**TOWN OF NEWBURGH
PLANNING BOARD
TECHNICAL REVIEW COMMENTS**

PROJECT: CORTLAND COMMONS
PROJECT NO.: 2017-11
PROJECT LOCATION: SECTION 9, BLOCK 1, LOT 60
REVIEW DATE: 28 JULY 2017
MEETING DATE: 3 AUGUST 2017
PROJECT REPRESENTATIVE: JMC PLANNING & ENGINEERING

Response to MH & E "Town of Newburgh Planning Board Technical Review Comments", dated 03/16/2017

CONCRETE BUMPER BLOCK

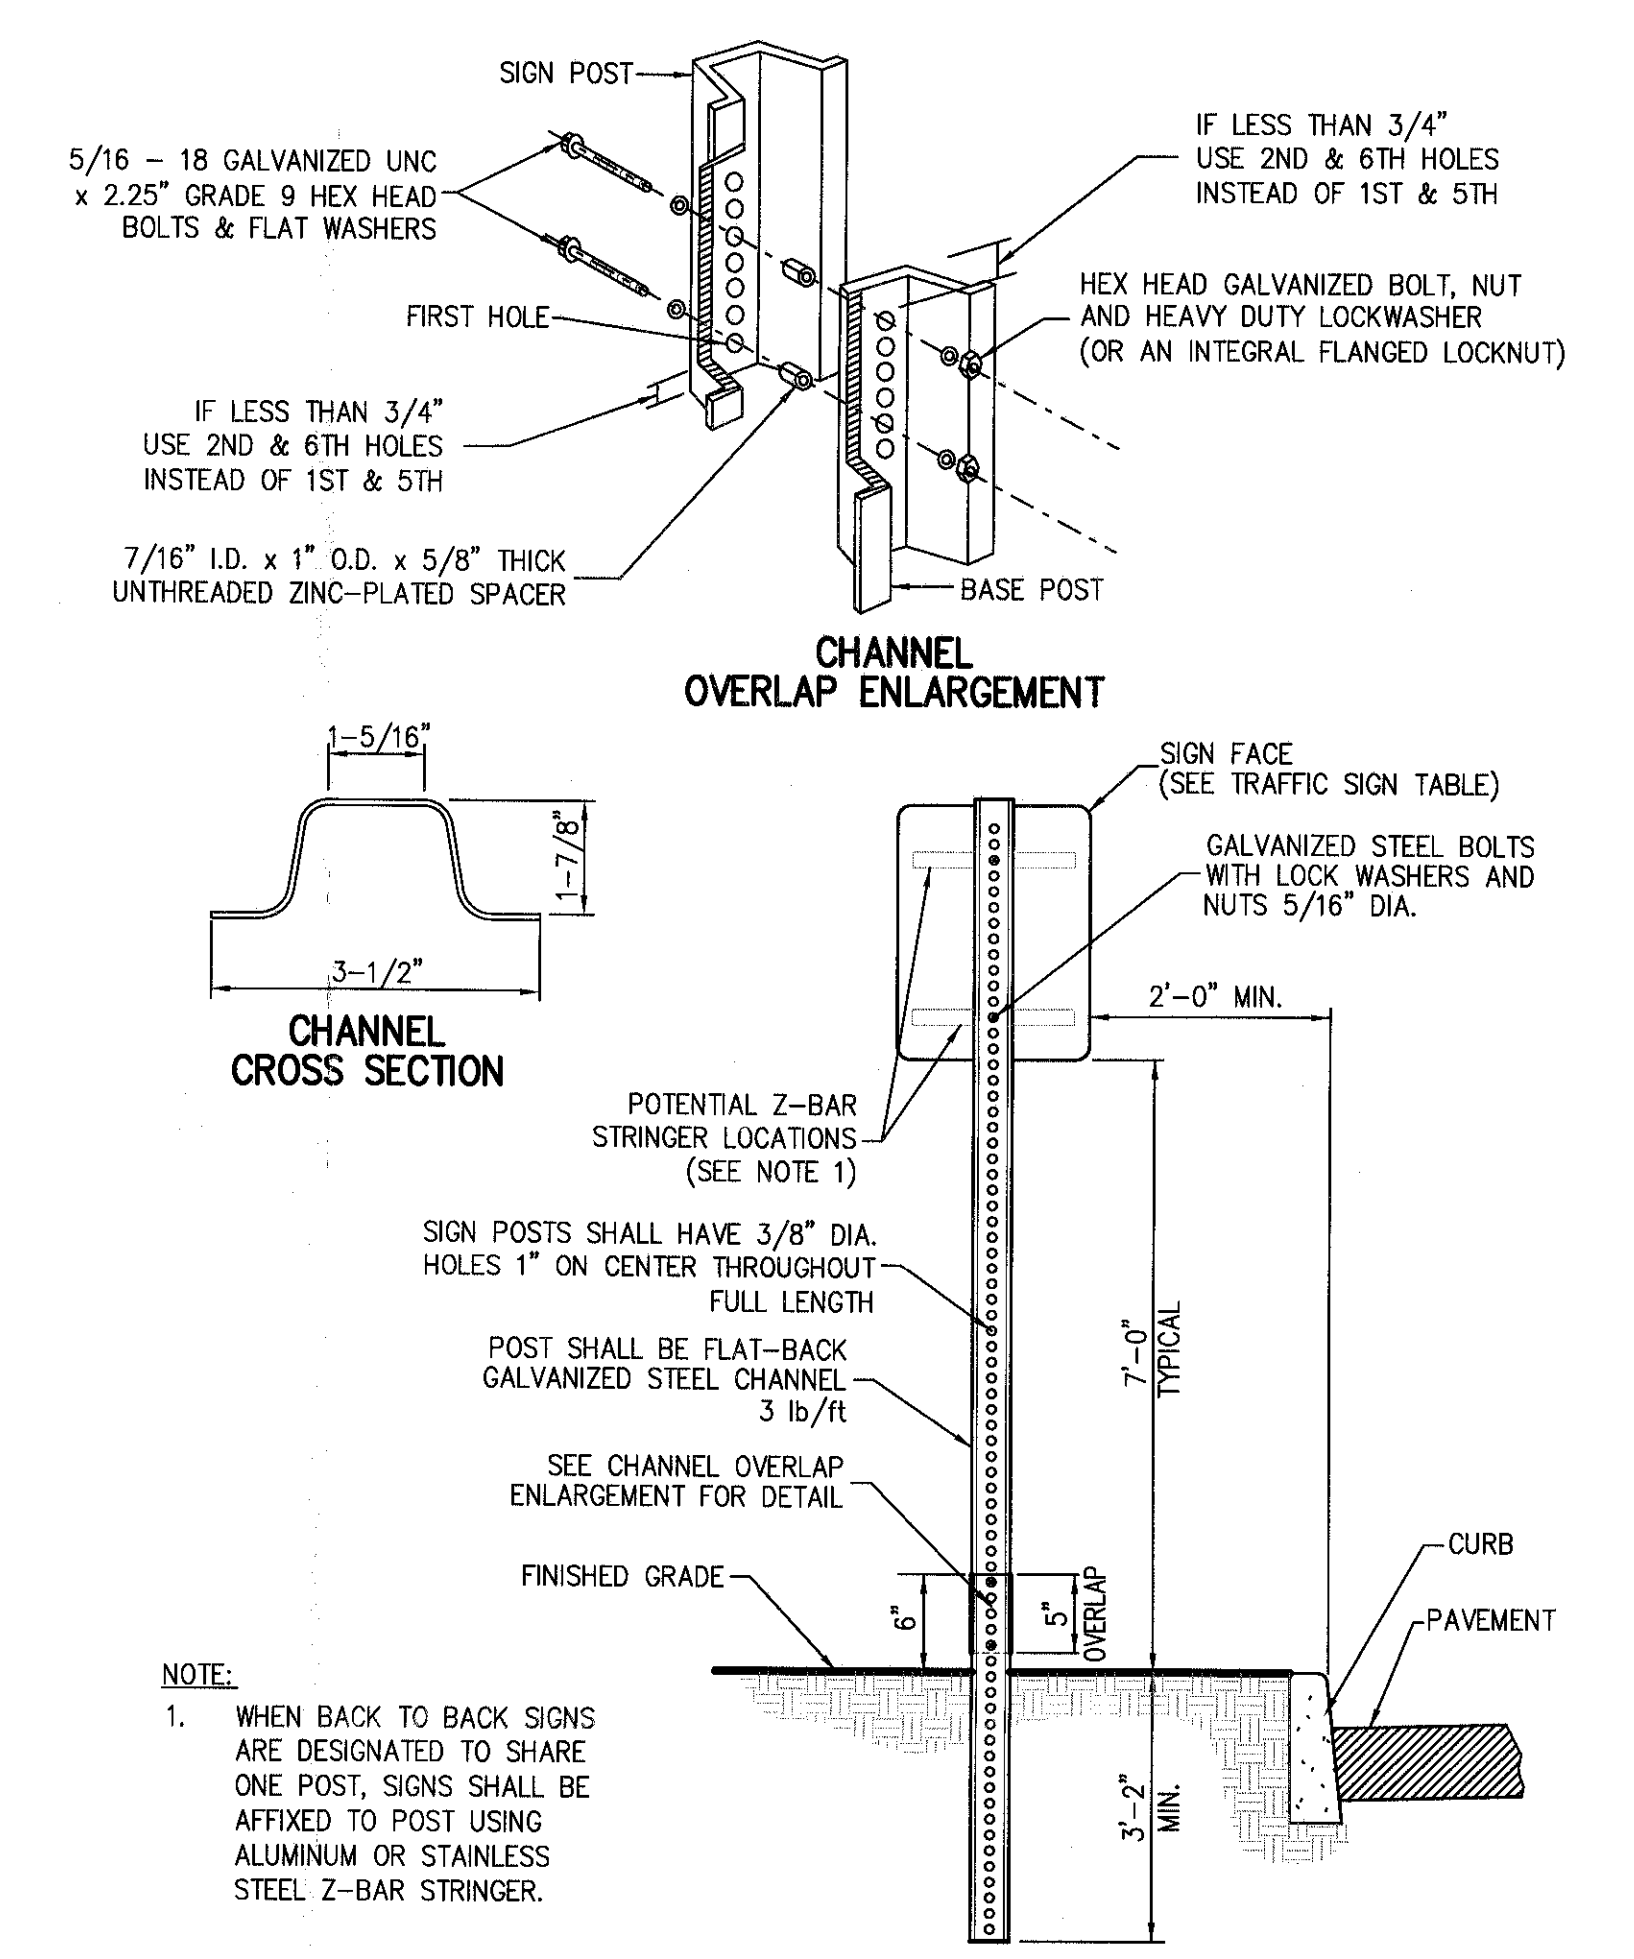
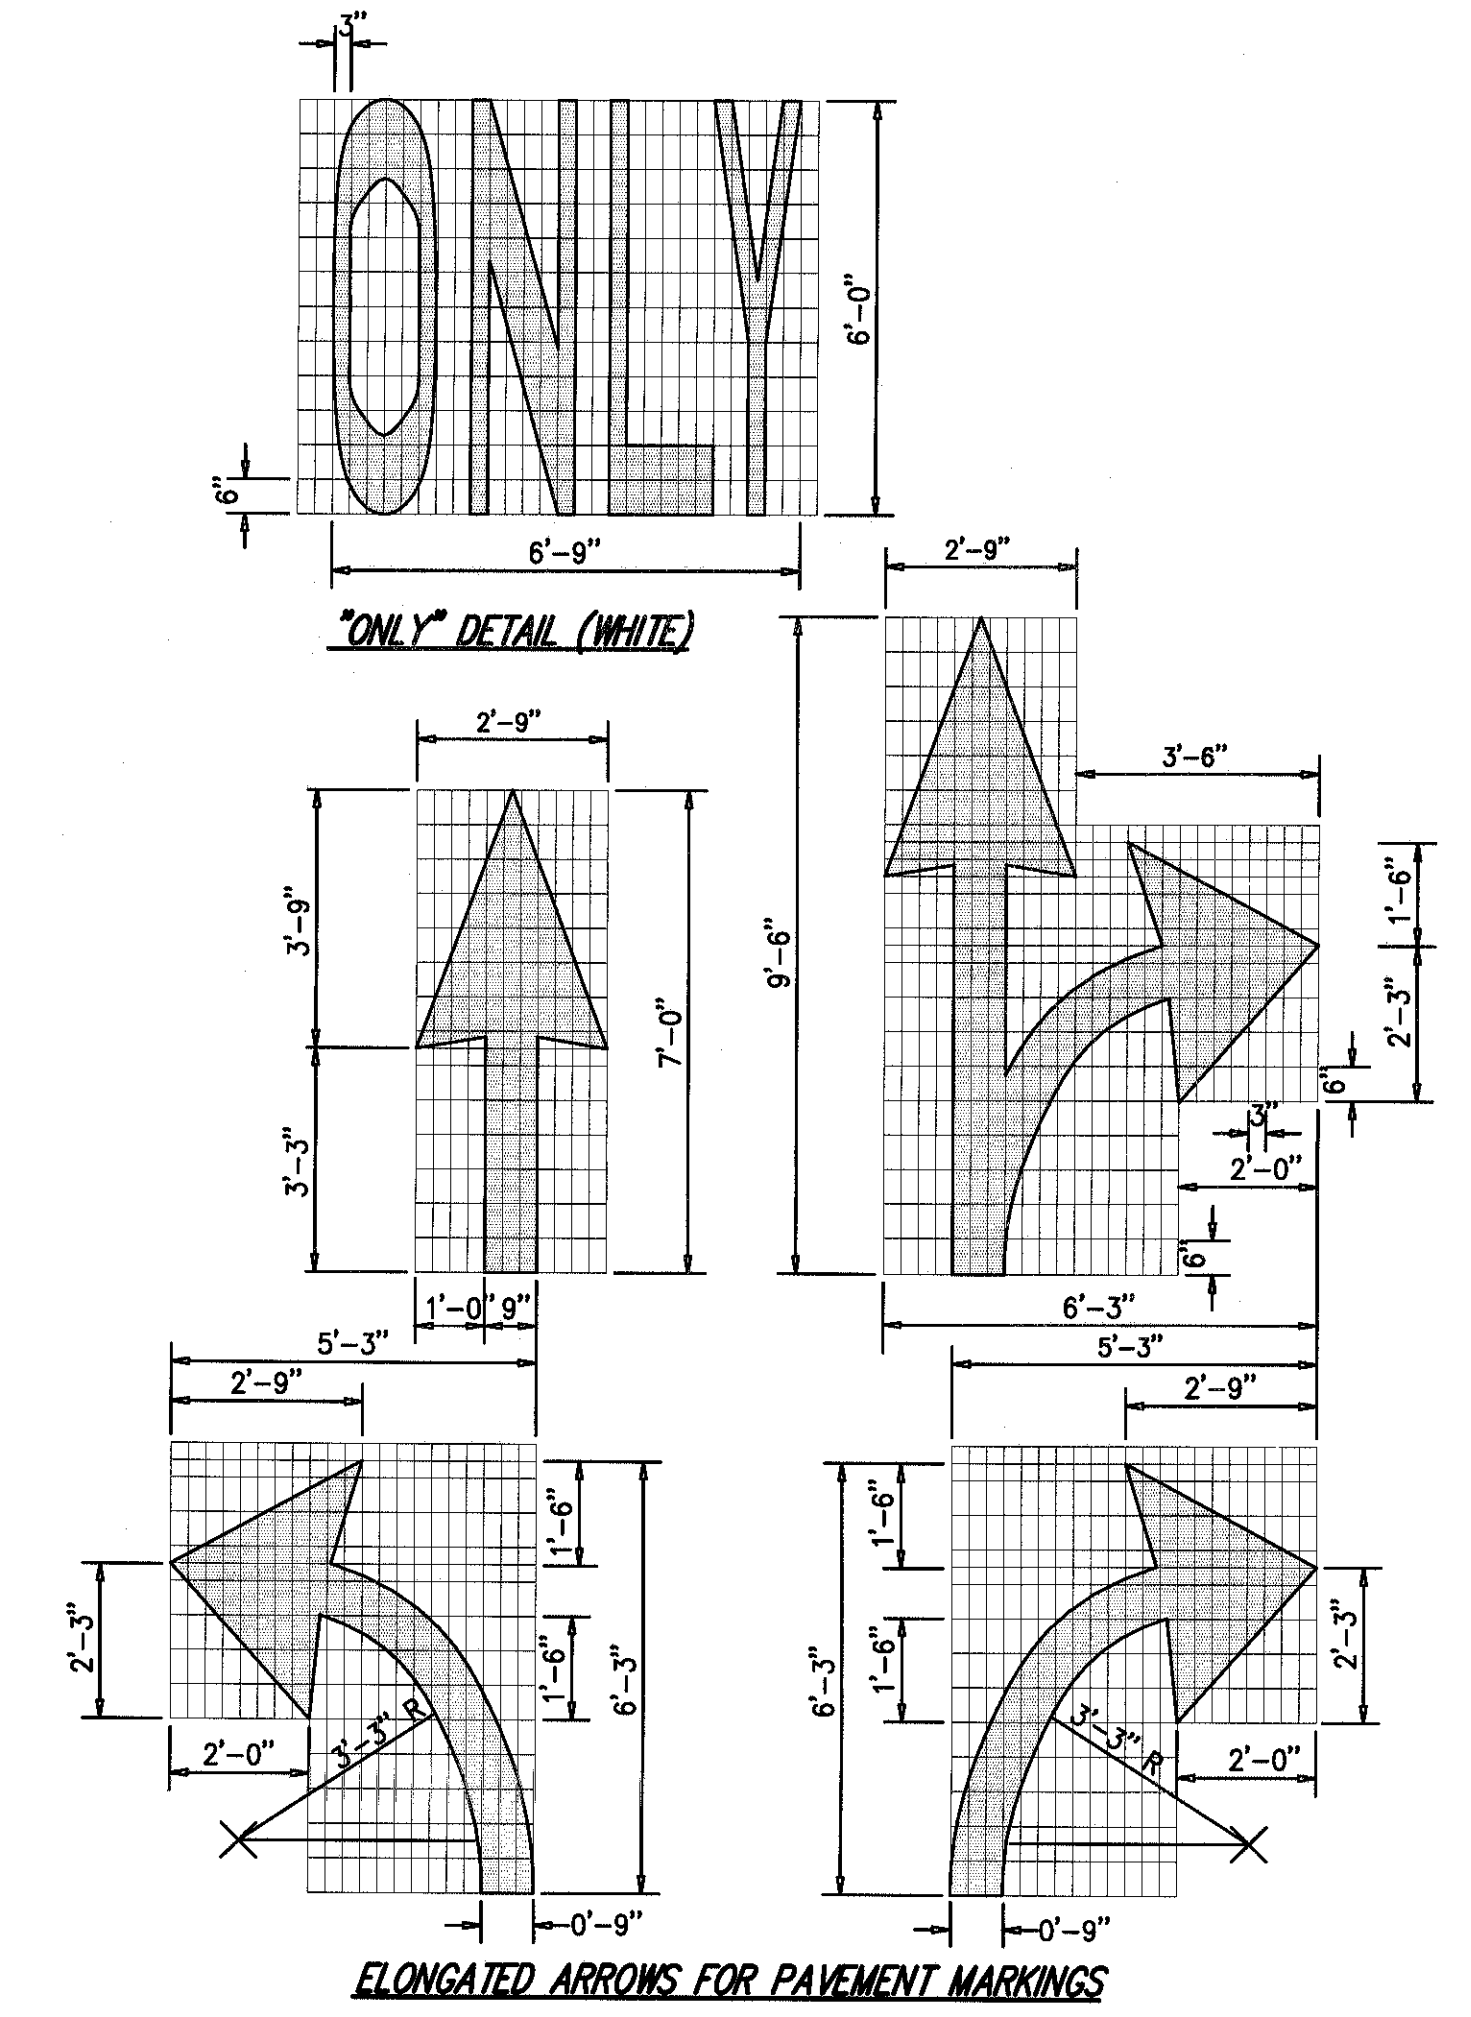
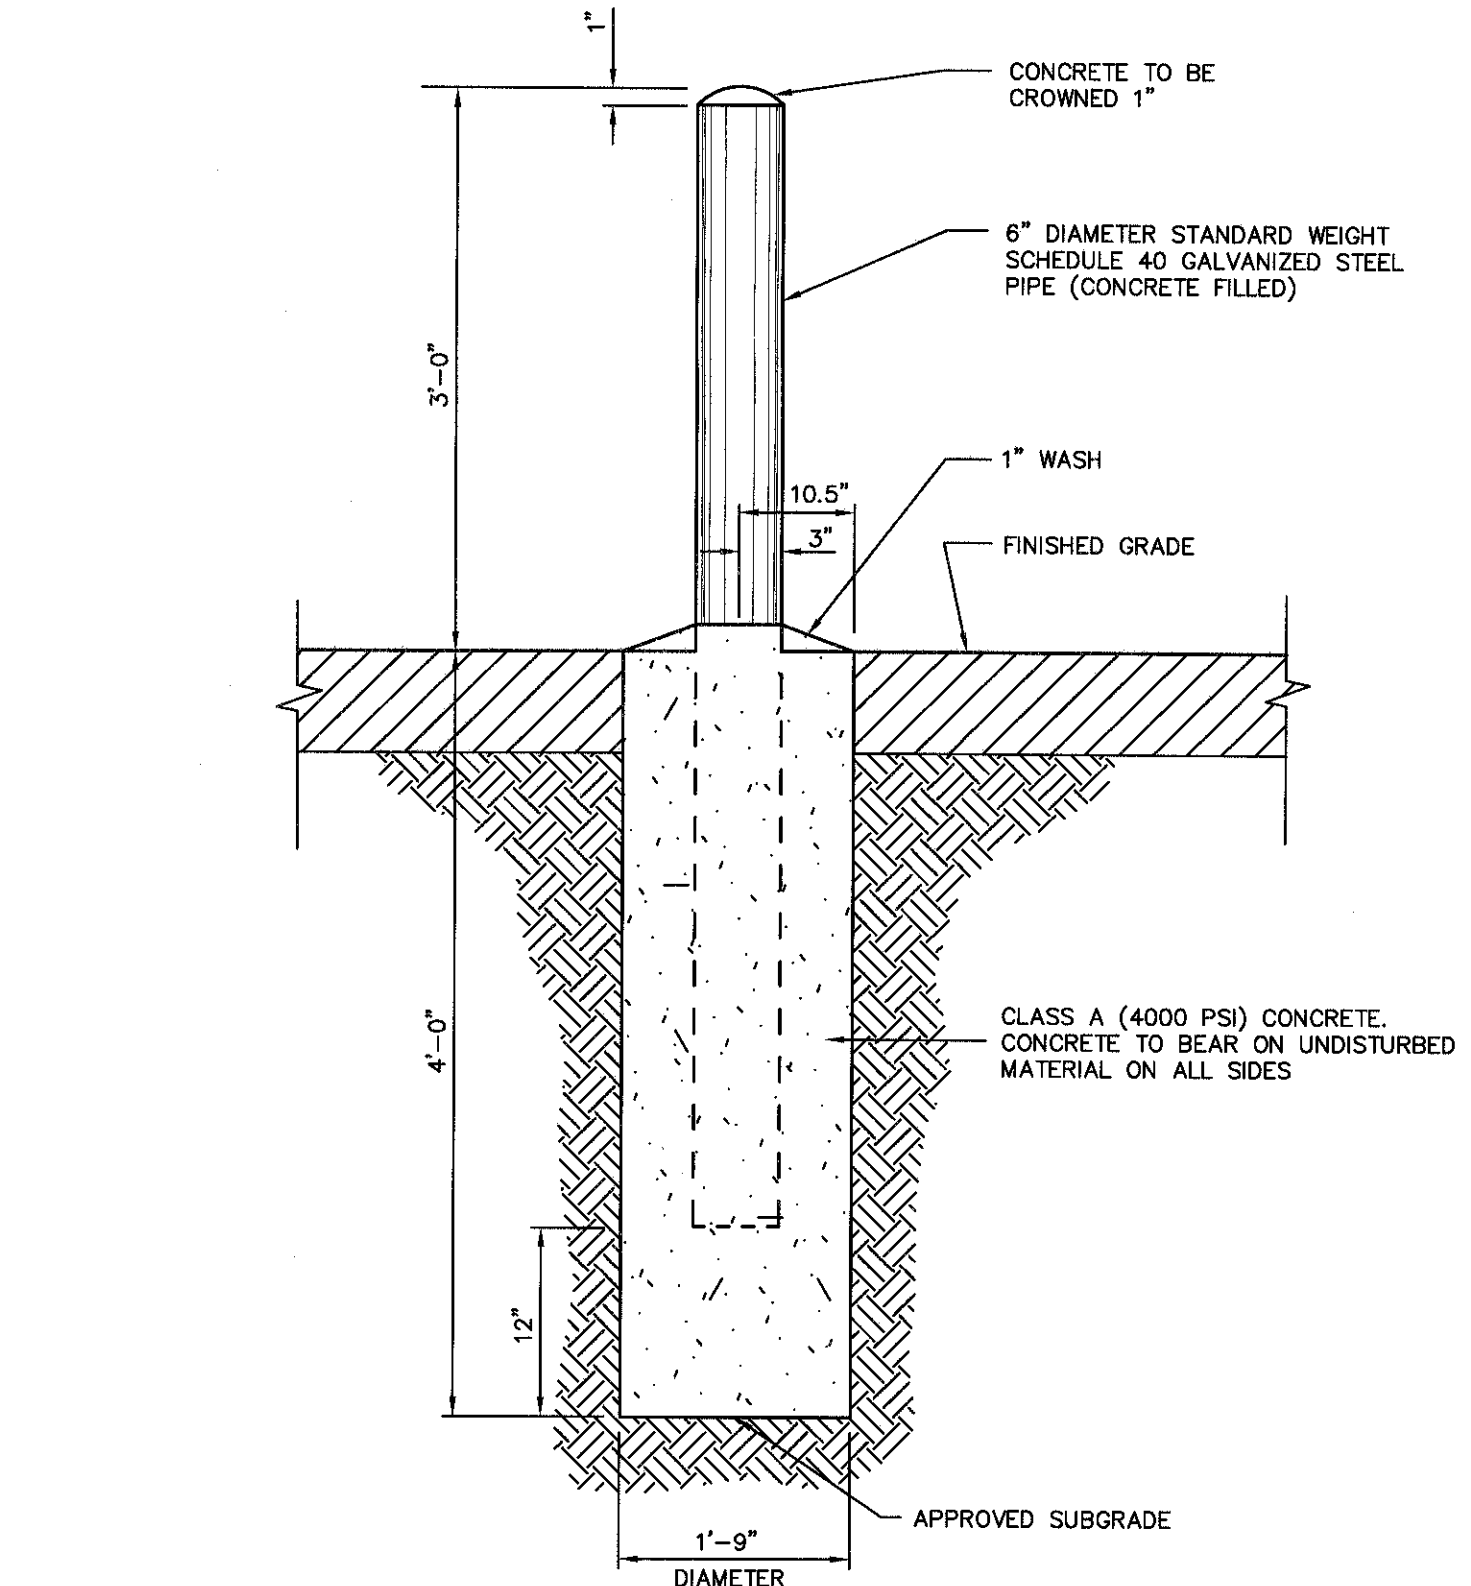
9. The Planning Board's attention is called to the use of concrete bumper blocks on the south west portion of the fast food restaurant and retail building. The Applicant's representative is asked to discuss the transition between the concrete curb and the at grade sidewalk on the south west portion of the retail building.
